Re: Initial Submission Review: Green Valley Ranch East – Site Plan No. 19, Plat Vacation and Plat
Application Number: DA-1662-35
Case Number: 2021-4010-01; 2021-3017-01; 2024-3030-00

On behalf of Oakwood Homes and Terracina Design, we have reviewed the initial submission comments dated July 16, 2024. The following is a response to comments.

**GREEN VALLEY RANCH EAST
SITE PLAN #19 W/ ADJUSTMENTS**

DEN Aviation Noise:

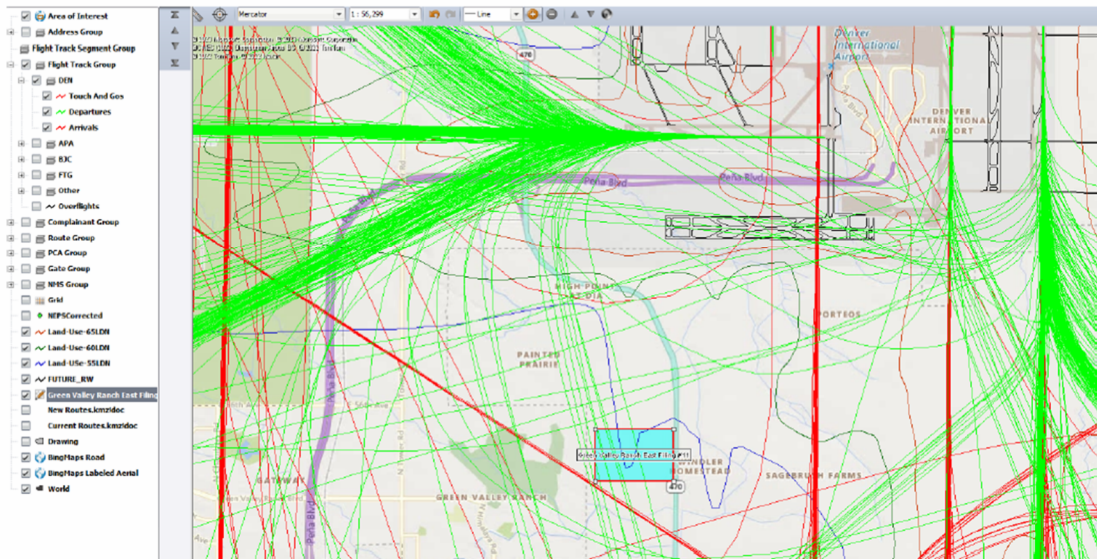
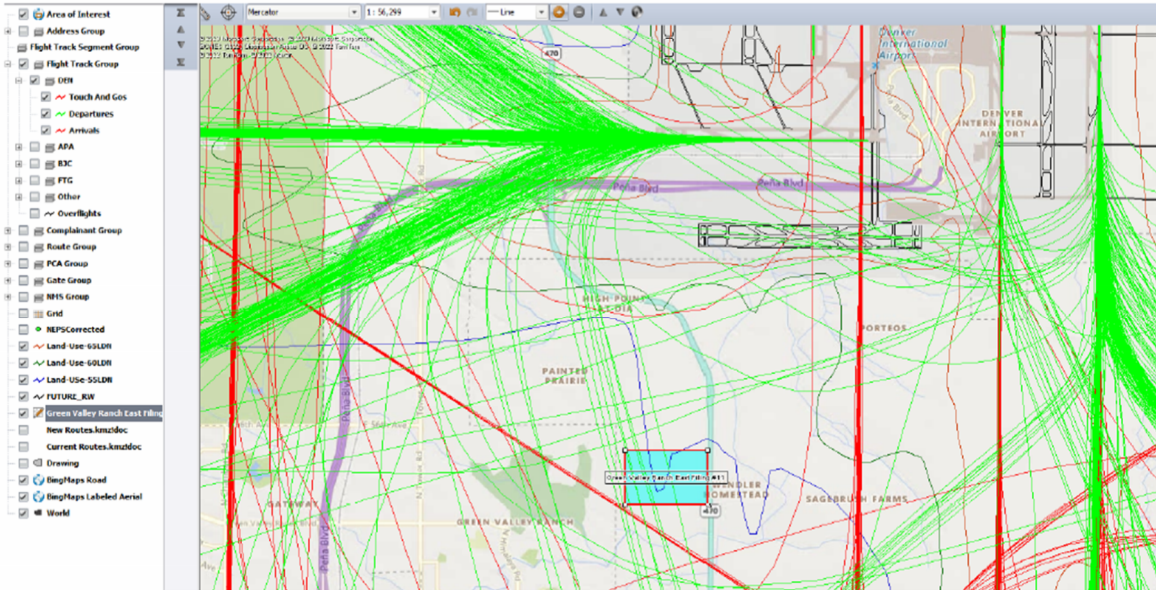
Same flight data from 2/28/23, zoomed in to see the 55, 60 and 65 DNL contour and the property area in light blue. The 55 DNL intersects the property on the north end. This portion of the 55 DNL pertains to the additional 2 potential north/south runways on the west side of the airfield. Once the runway straight north of this property is built, 16C/34C (might be the runway names) there will be overflights at the beforementioned altitudes. There could be upwards of 200+ arrivals per day to those future runways.

Flight data from 2/28/23. Few arrivals vectoring to get in line for final approach to 34L or 34R and there are also some departures that could fly near the subject property. On this day there were a few departures from runway 17L and 17R as well as runway 25. Their altitudes can vary based on aircraft type. On this day they were between 2,600 feet AGL and 4,100 feet AGL. These aircraft will be louder than arrivals as they are under full power departing DEN. During periods of high winds, inclement weather or runway capacity issues the FAA will depart aircraft to the south from runways 17L/R and then turn them west to get back onto the final assigned pattern. This could happen from any one of the north south runways. For the same reasons noted above, the FAA will direct departures from runway 25 to depart west and then turn to the south to then get them onto their final assigned pattern.

SIGN LEGEND:

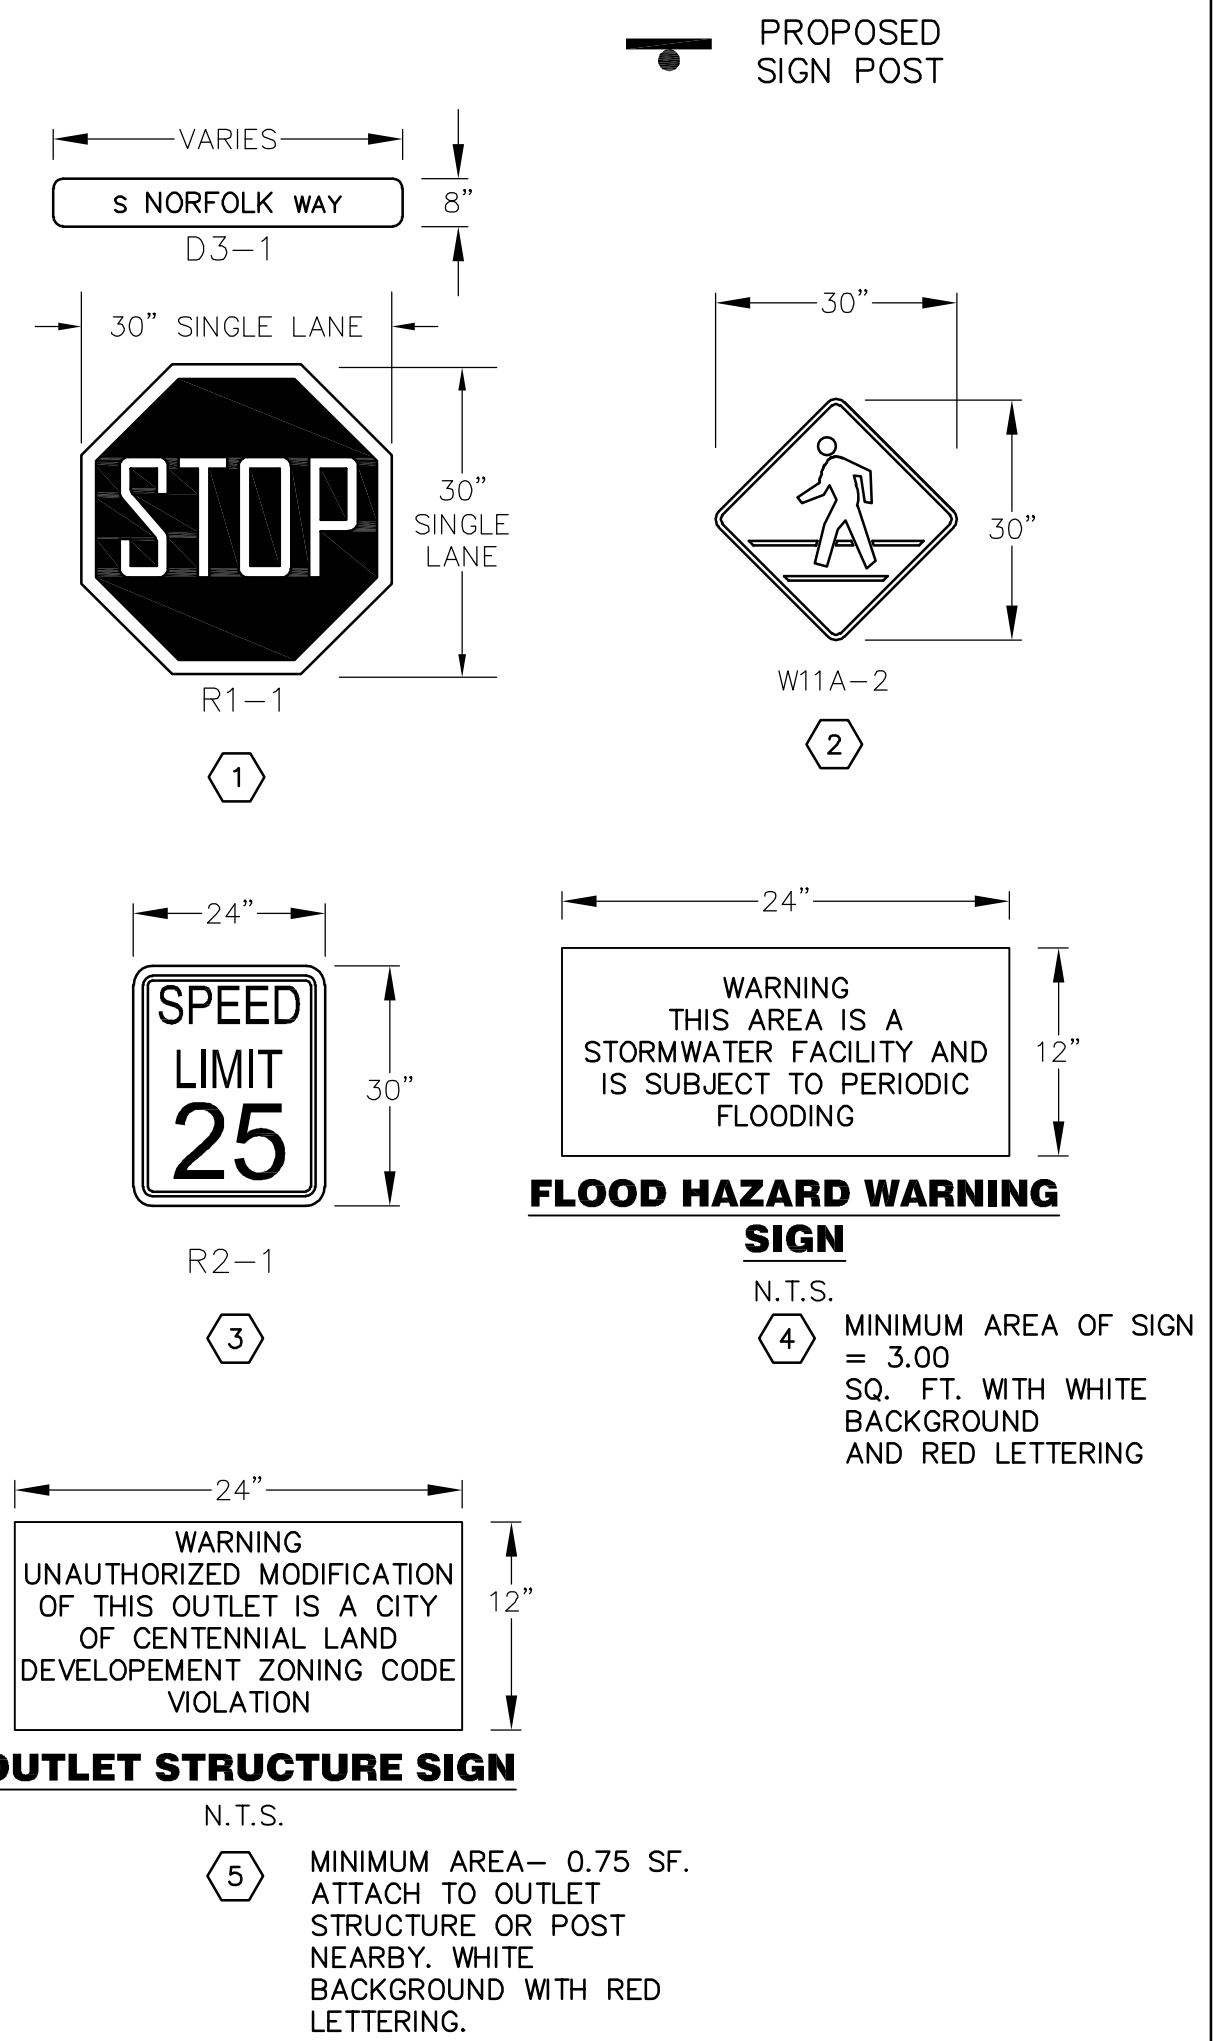
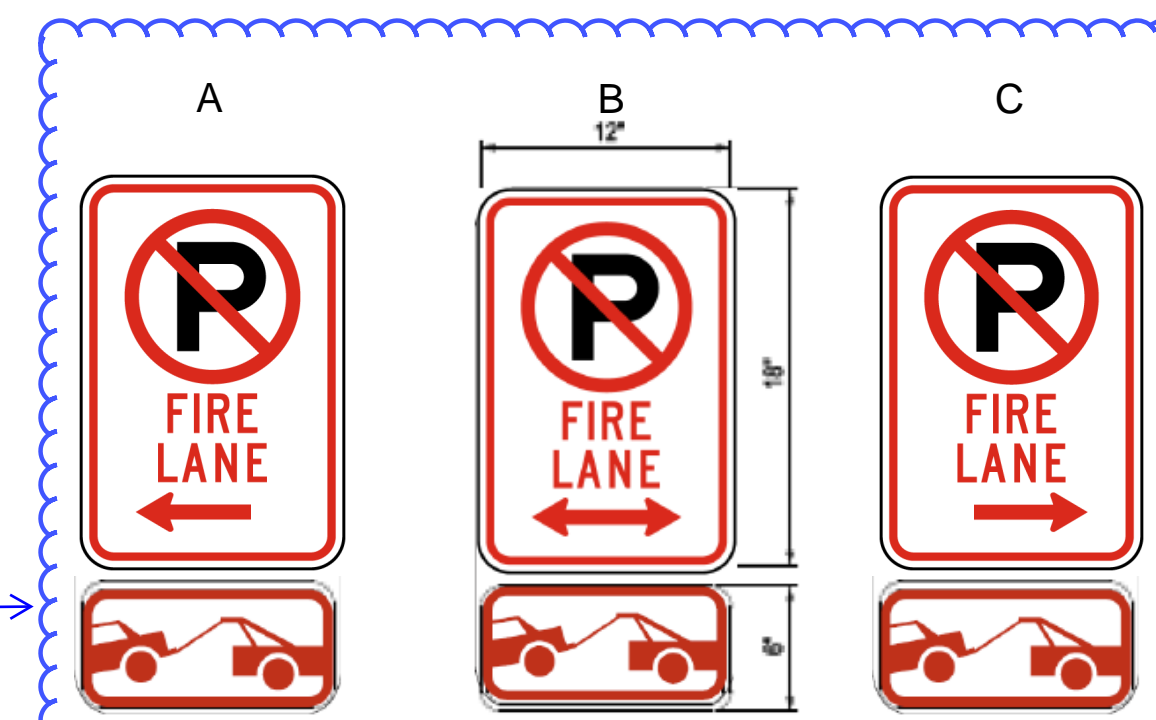
Add fire lane sign to the legend.

Fire Lane sign details and notes.

Fire lane signs added.

Fire lane sign details and notes added. Per coordination with Mark Apodaca - fire lane signage placed 200' on one side and 100' alternating.

GREEN VALLEY RANCH EAST
SITE PLAN #19
TITLE: LANDSCAPE DETAILS
DATE: June 7, 2024

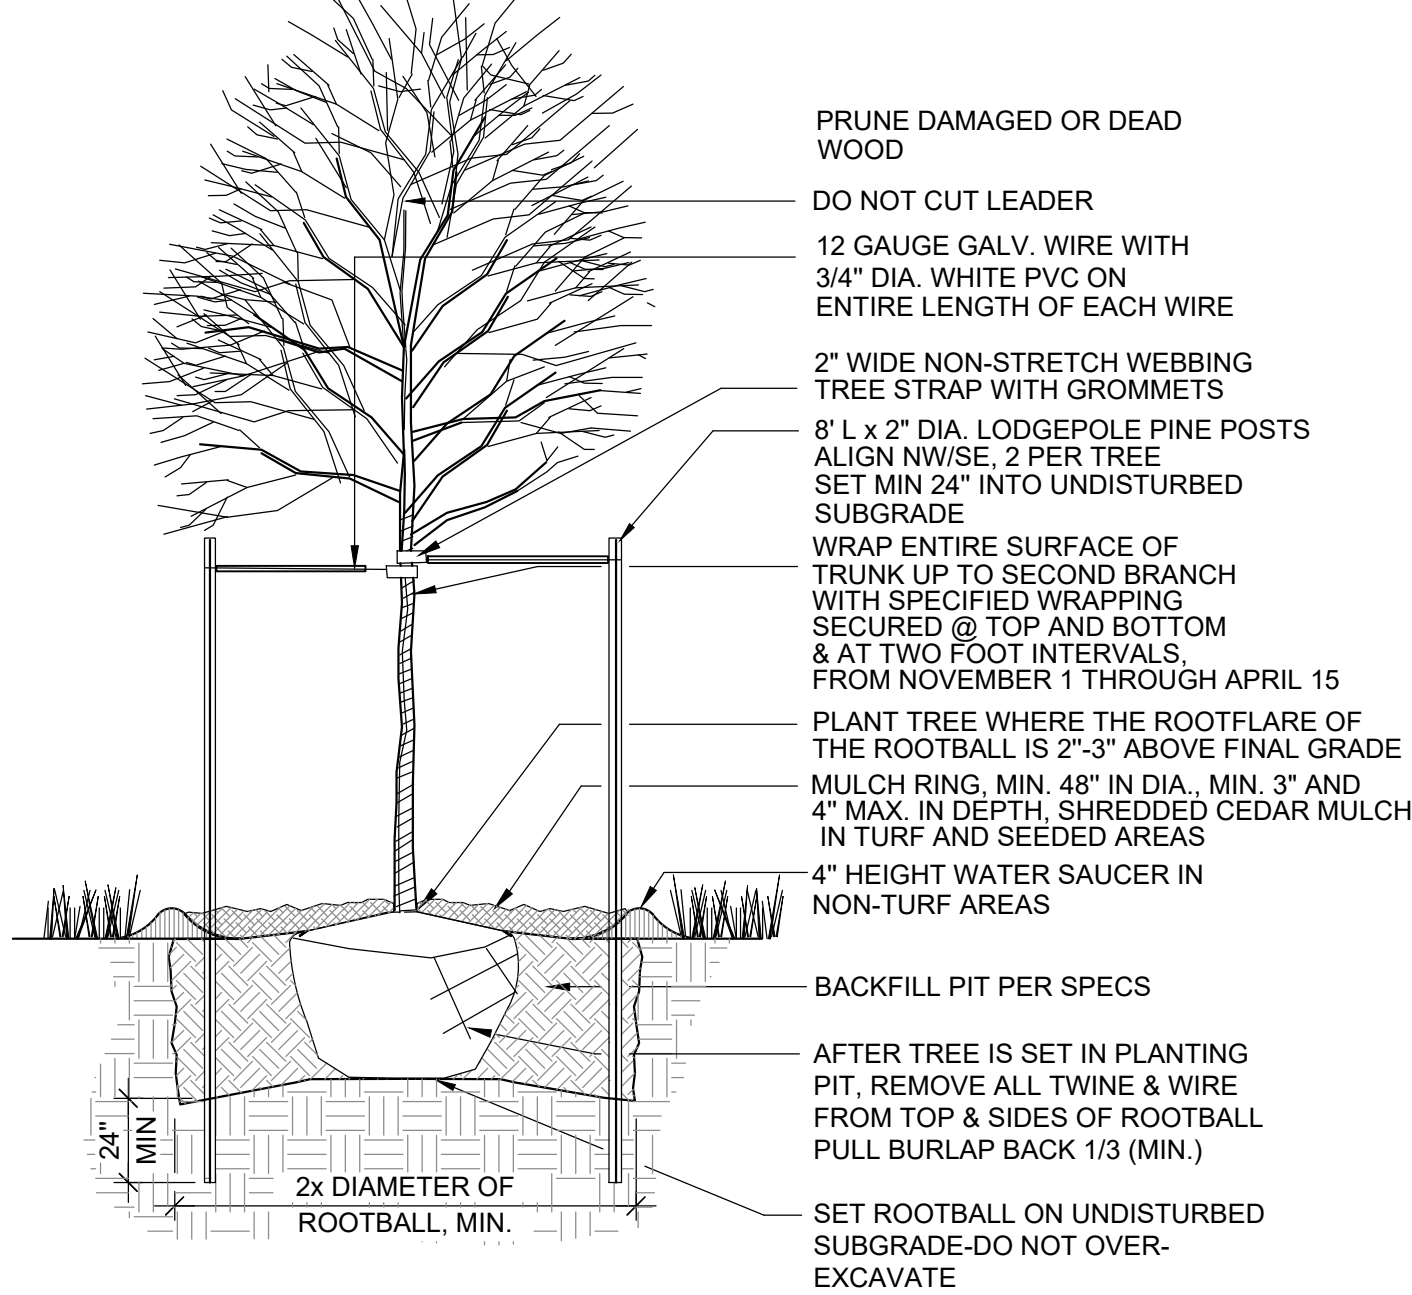
is this a different fixture than the one used on the streets?

NOTE ADDED.

3 MAIL BOX KIOSK LOCATION B
SCALE: 1:10

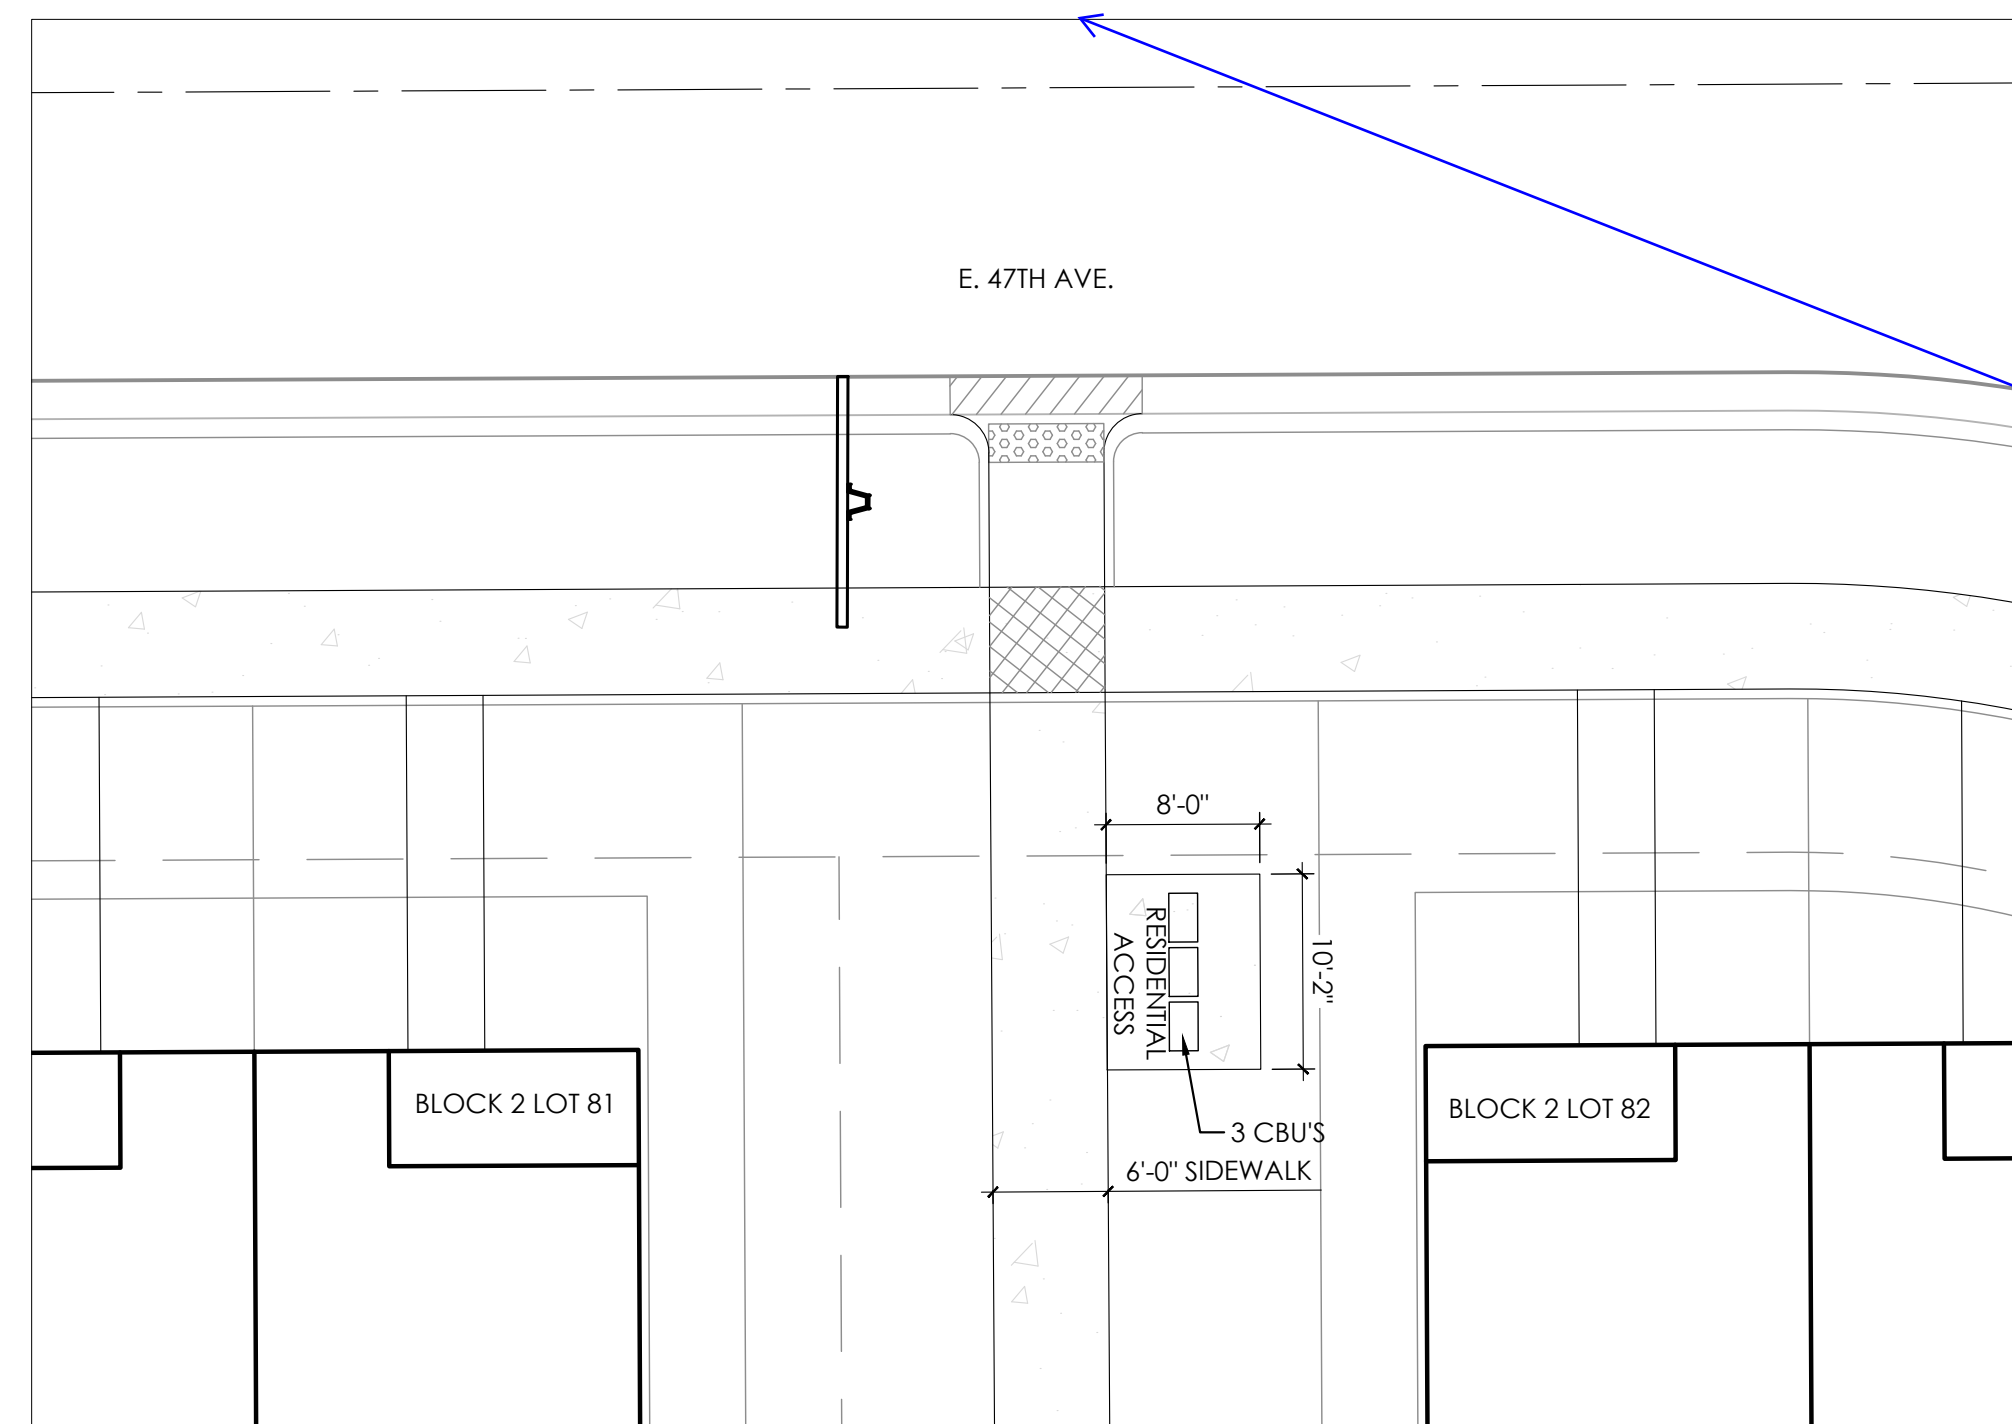
Show curb ramps.

CURB RAMP ADDED. VIEWPORT EXPANDED TO SHOW CONNECTING CURB RAMP.

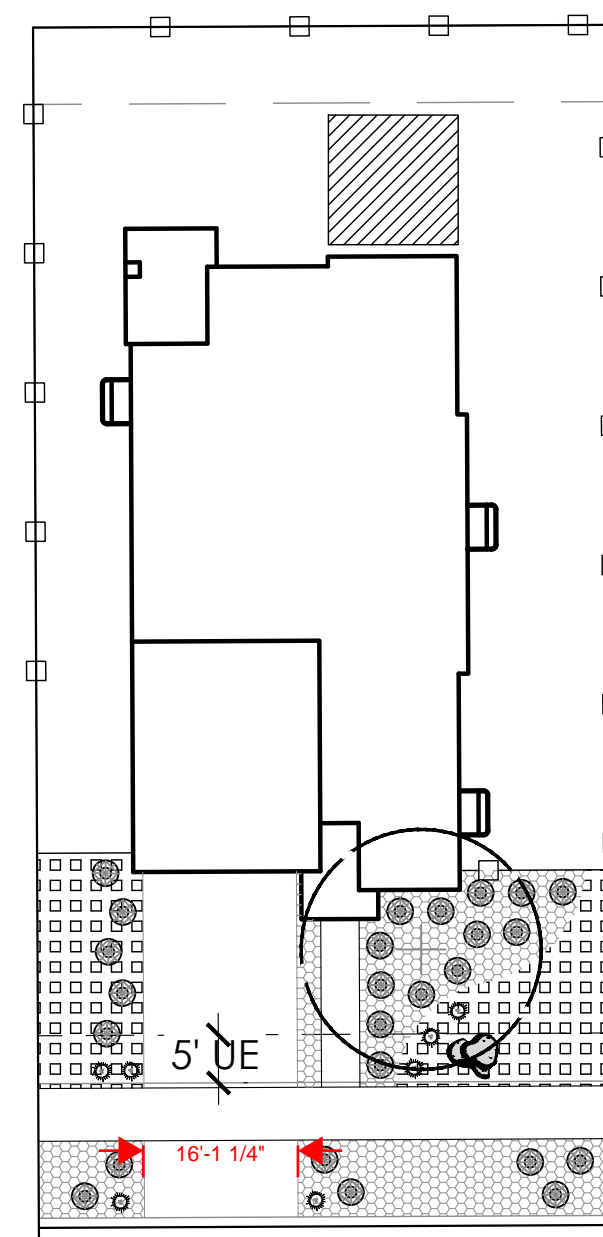
include special
feature for each lot.
List of eligible items
is ok.

ADDED CALLOUT
FOR SPECIAL
FEATURE ON EACH
TYPICAL.
